DEVELOPMENT ASSESSMENT CASE NUMBER: CD-2022-0002 – 311-315 South Congress
Planned Unit Development

COMMENT REPORT

PROJECT NAME: 311 - 315 South Congress PUD

TREE LIST	
NUMBER	DESCRIPTION
5000	17" LIVE OAK
5001	8" LIVE OAK
5002	9" LIVE OAK
5003	15" LIVE OAK
5004	13" ASH
5005	33" ASH
5006	23" ASH

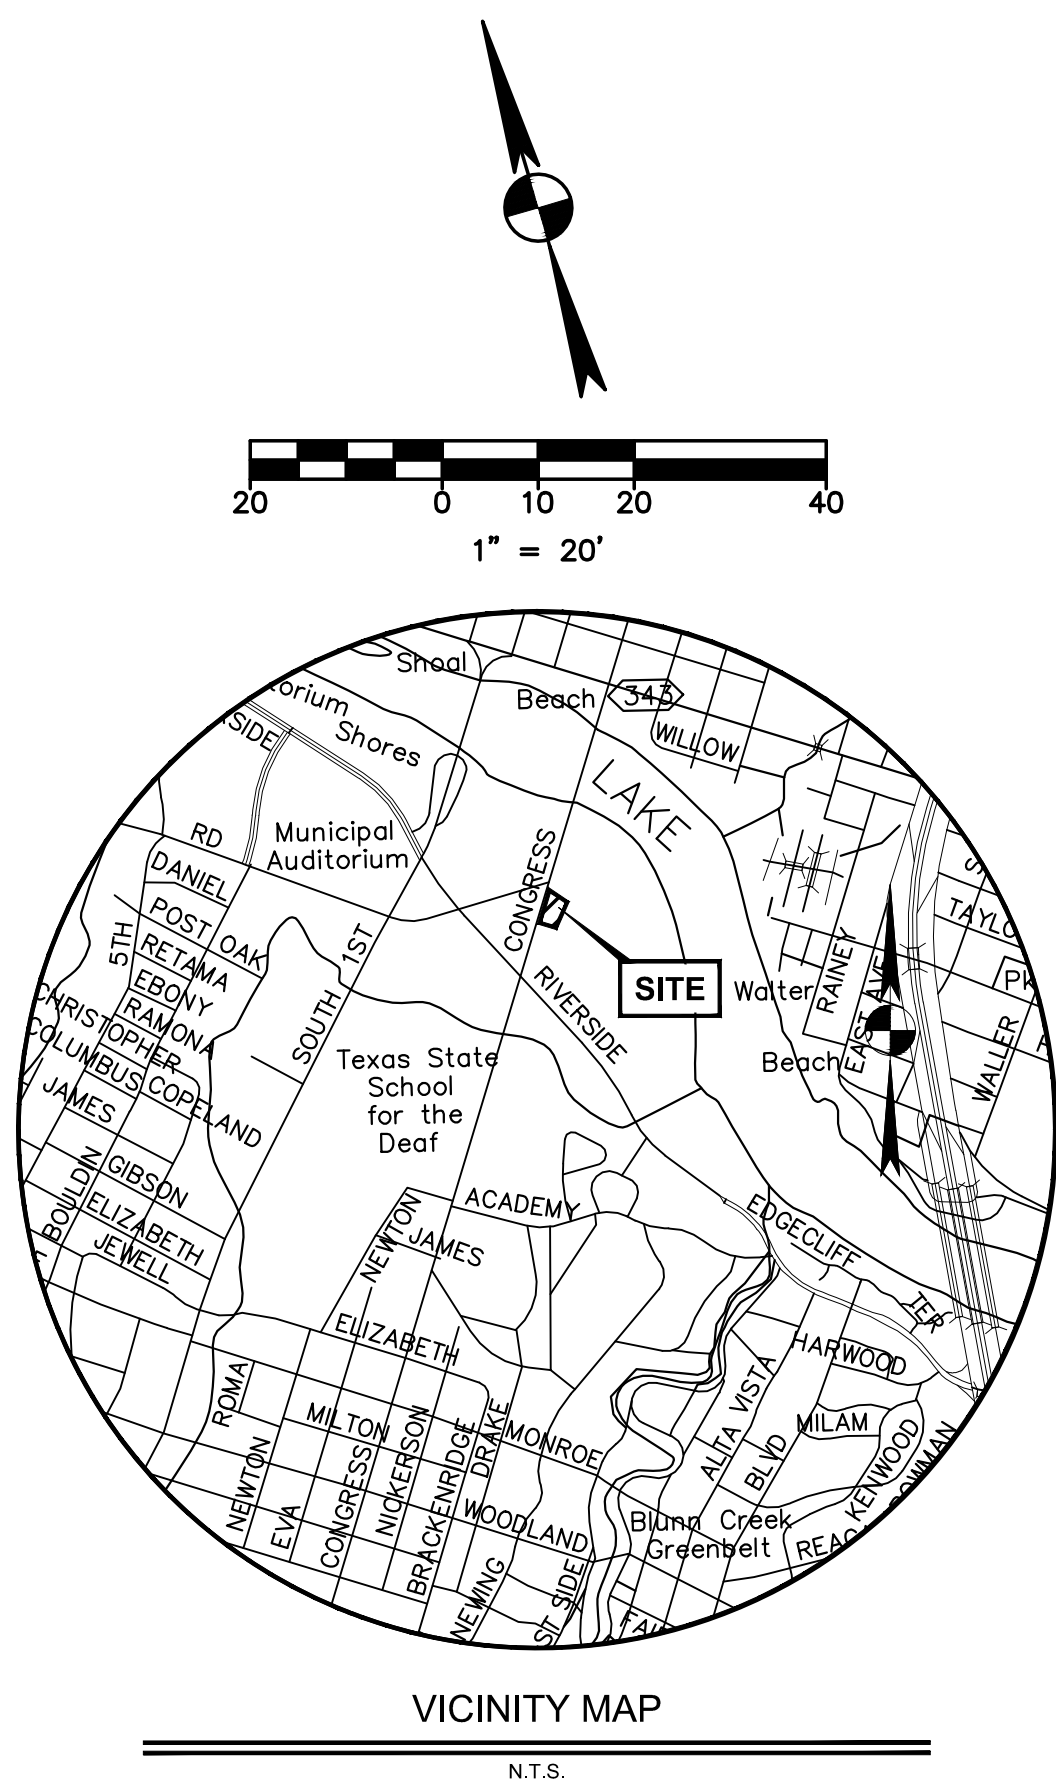
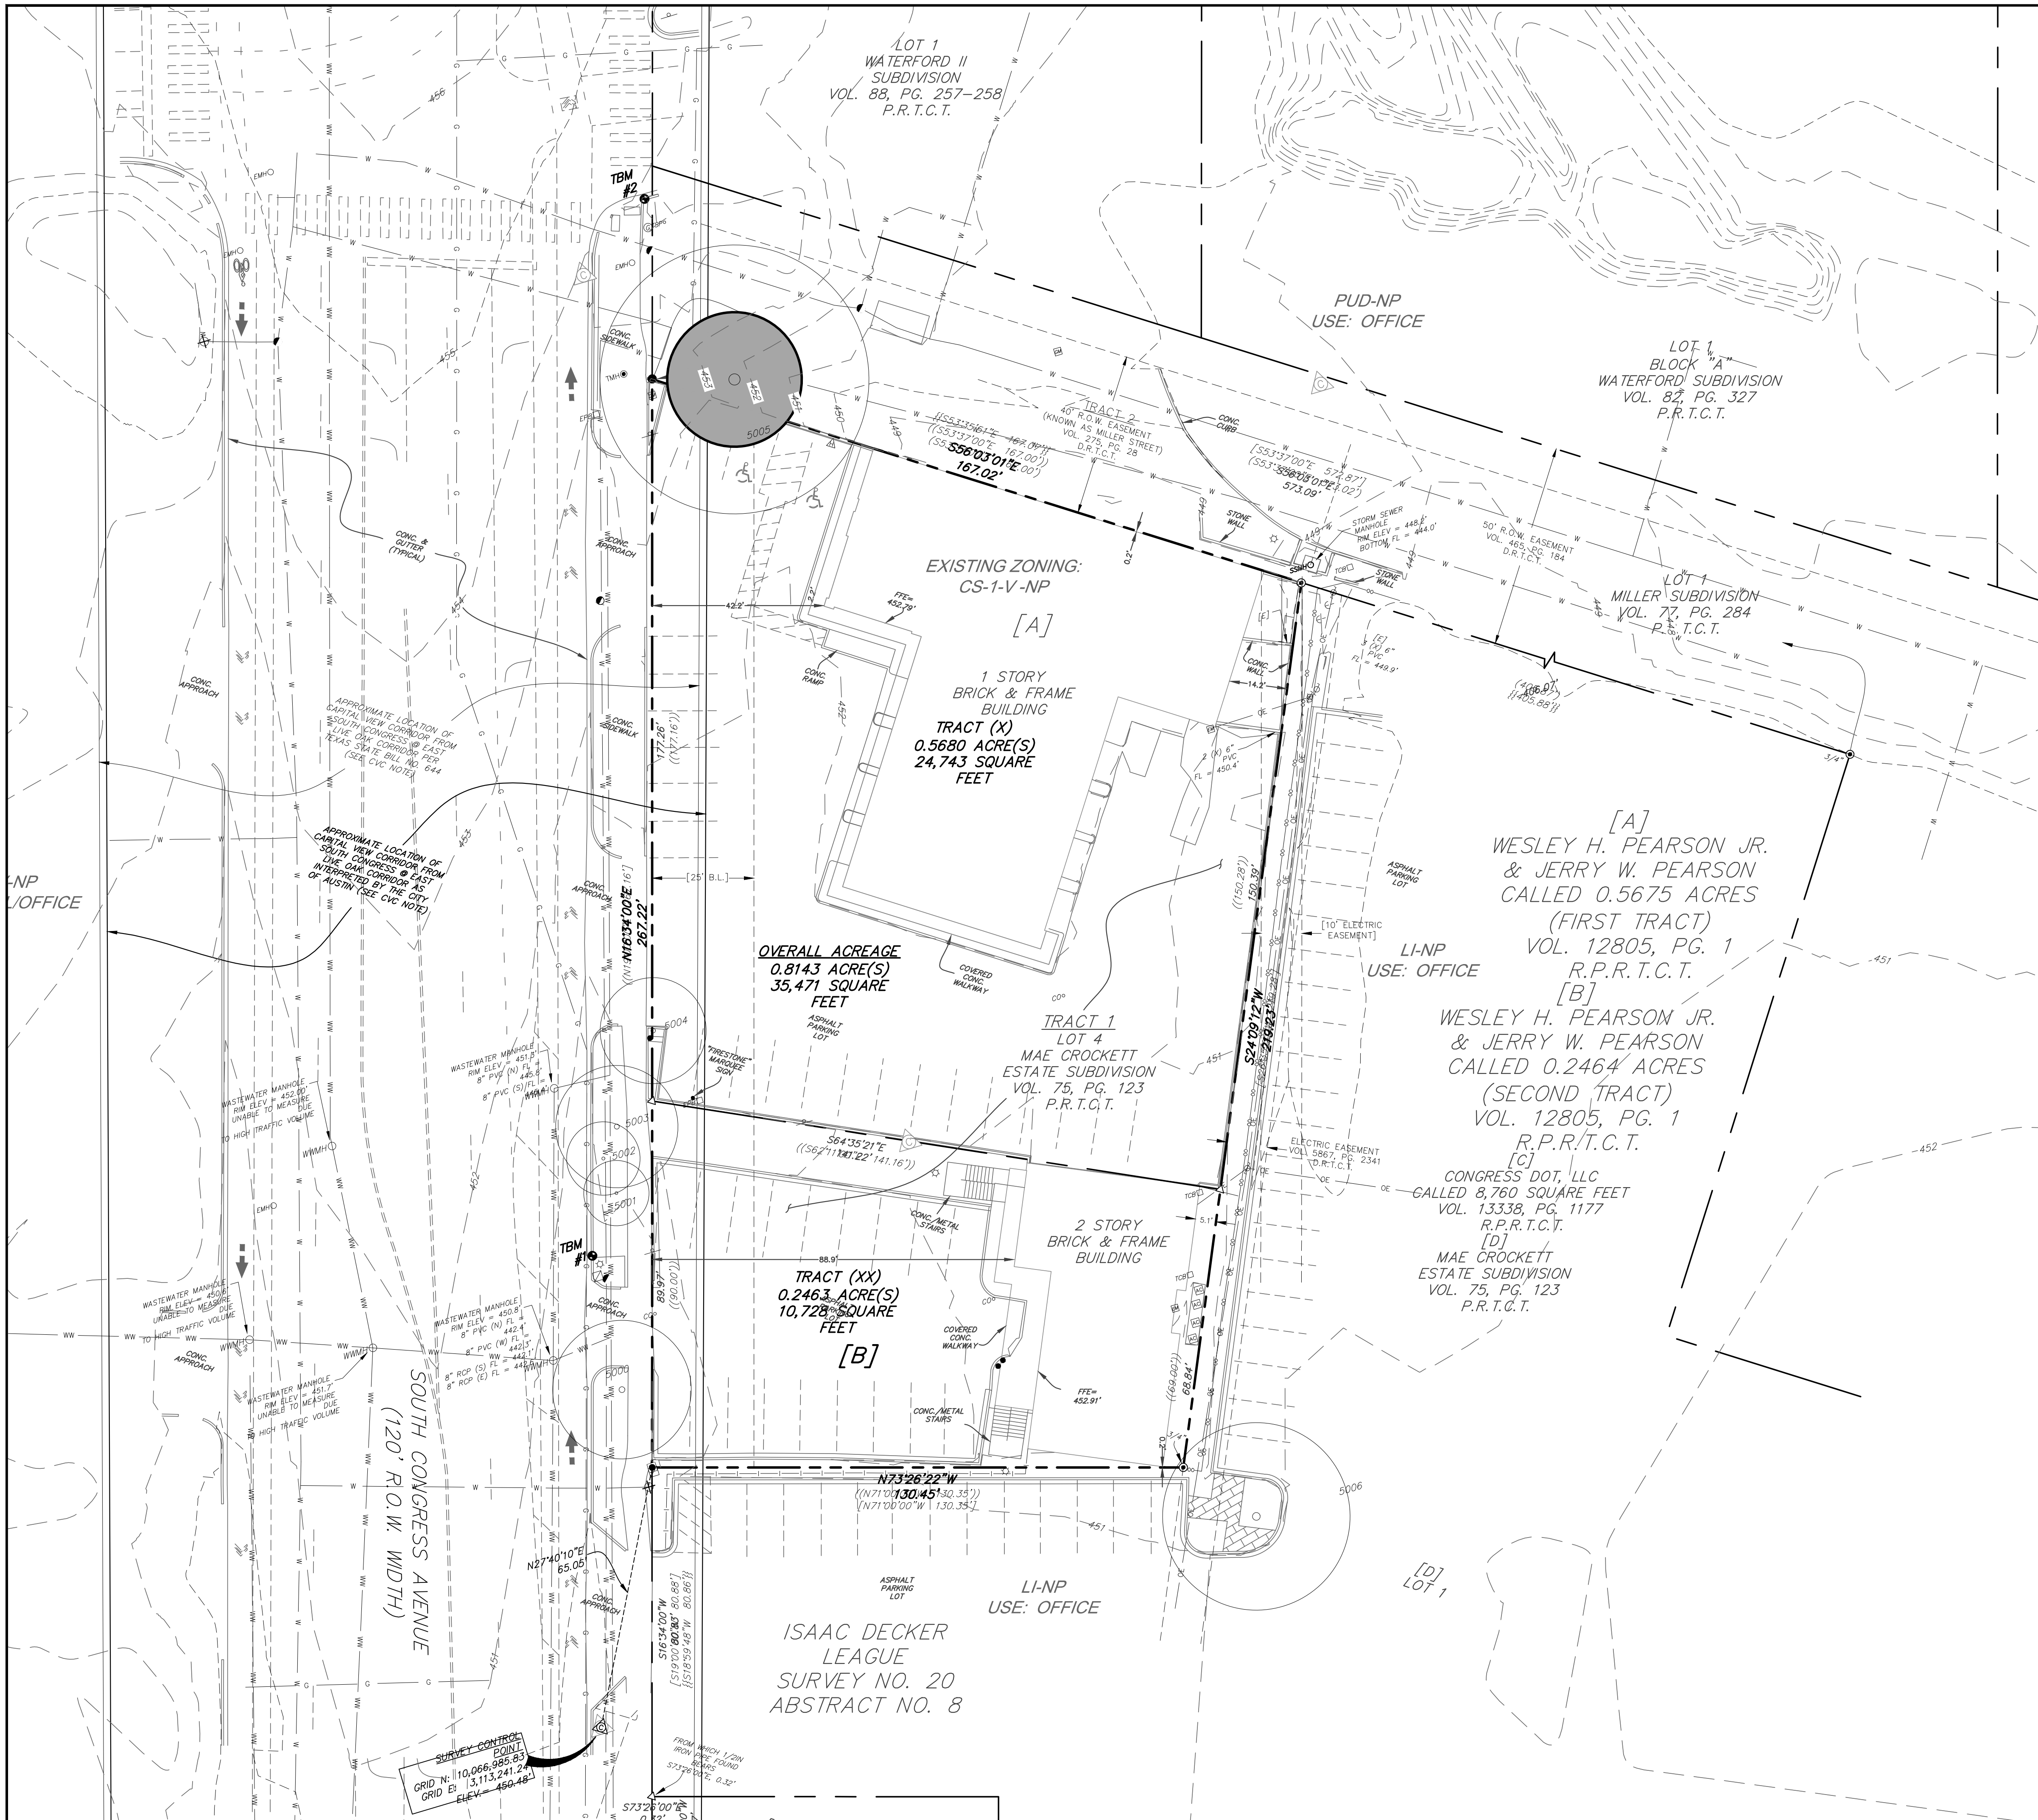
- CA 5 Please clarify the tree survey as Tree 5005, a 33” Arizona ash. The City has previously issued a dead diseased imminent hazard tree permit for its removal.
